## Tech Notice for FlightPower 2S, 4S, & 6S Battery Packs

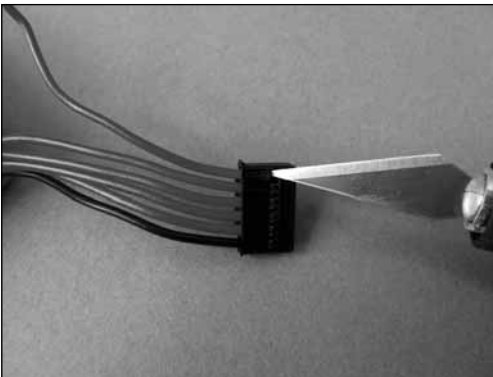
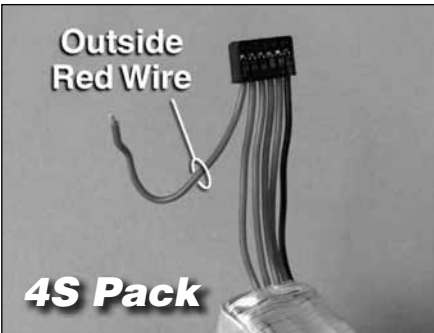
The indicated red wire leads on these three packs, may come detached from the battery. While these wires are attached to the balance connector, they are **not connected** to the battery circuitry. The battery will charge and discharge properly without these wires attached to the battery or the balance lead.

It is recommended that you remove these wires from the balance connector. This can be done by using a hobby knife to pry the plastic retaining clip and removing the wire. This is only recommended for Flight Power 2S, 4S, and 6S packs.
